PD Modification Application:

PRS 22-0941

BOCC Land Use Meeting Date: 08/25/2022

Request: Minor Modification to PD

2.4 Proposed Site Plan (partial provided belowfor size and orientation purposes. See Section 8.2 for full site plan)

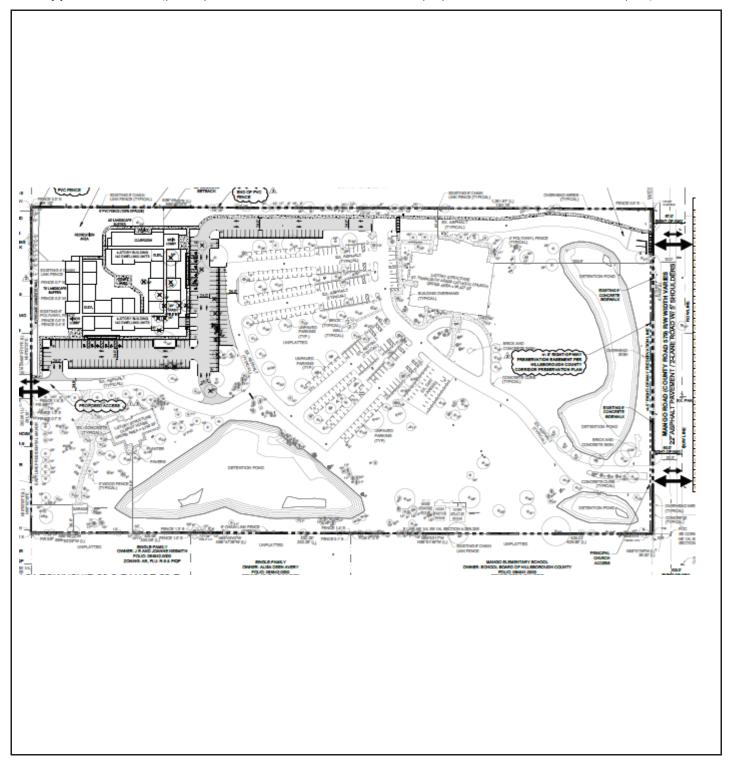
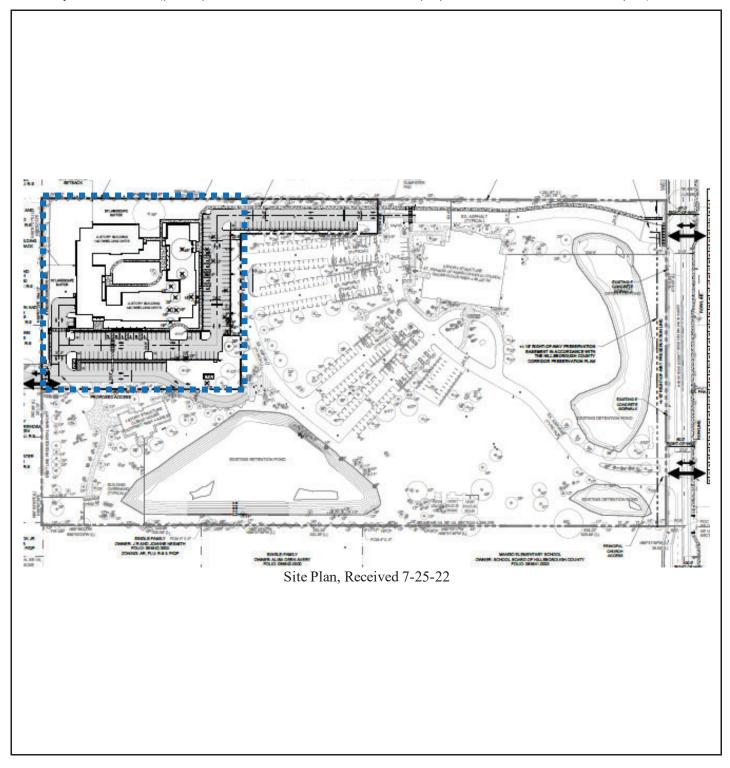
The purpose of the modification is to modify the modify the conditions of approval and reflect the changes on the site plan. The applicant proposes to (1) increase the maximum building height from 45 feet to 55 feet; (2) request a waiver of the 2-ft. setback for every foot over 20 feet in height; (3) amend the buffer on the north property boundary.

The applicant is requesting to replace the requirement of an opaque screening (i.e., 6 ft. PVC fence) at northern boundary with a non-opaque landscape buffer (i.e., chain link fence that currently exists on the subject property). The applicant proposes to maintain the current condition requiring a 5-foot Minimum Landscape Buffer along the northern property boundary. The applicant states, the modified screening is necessary to allow future residents to enjoy ground level vistas adjacent to the county park. Additionally, the applicant proposes to keep the 50-foot Landscaped Buffer (pursuant to PD 21-0297) along the north side of the proposed 4-story building adjacent to the county park.

The applicant proposes to replace with the required 6-foot PVC fence with an existing chain link fence located on the northern property boundary with the county park. The applicant also proposes an additional vegetated screening along the northern 50-foot buffer area consisting of the following which shall be conditioned, if approved.

- 3.1 The proposed modified buffer along the north property boundary shall consist of the following:
 - o Evergreen plants, at the time of planting, shall be four feet in height;

- o Chain link fence six feet in height;
 - Existing chain link fence may be used.
 - o <u>Lawn</u>, low-growing evergreen plant, evergreen ground cover, and mulch covering the balance of the buffer;

- O A row of evergreen shade trees a minimum of two-inch caliper which are not less than ten feet in height at the time of planting, and are spaced not more than twenty feet apart. The trees shall be planted staggered ten to twenty feet of the property line.

ATTACHMENT J

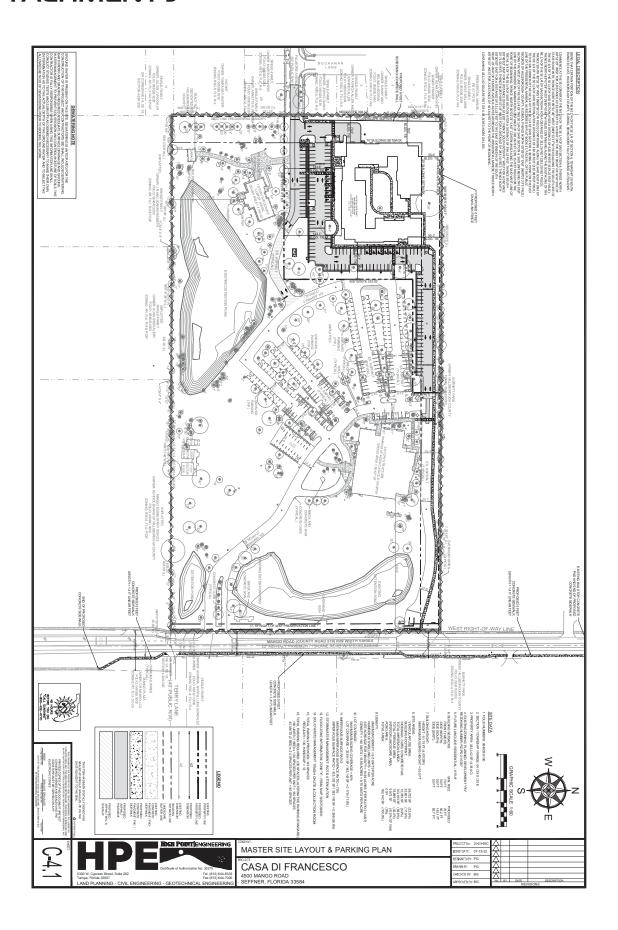
In addition, the applicant is preserving ± 18 feet of right-of-way along their Mango Road frontage in accordance with the Hillsborough County Corridor Preservation Plan, as shown on the PD Minor Modification Plan provided as **ATTACHMENT J**.

ATTACHMENT J

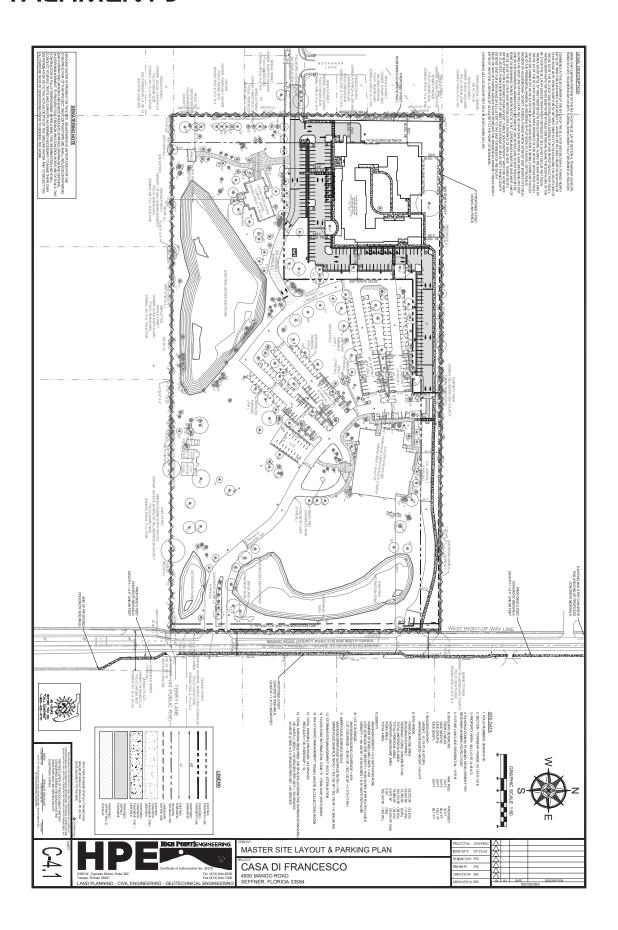
In addition, the applicant is preserving ± 18 feet of right-of-way along their Mango Road frontage in accordance with the Hillsborough County Corridor Preservation Plan, as shown on the PD Minor Modification Plan provided as **ATTACHMENT J**.
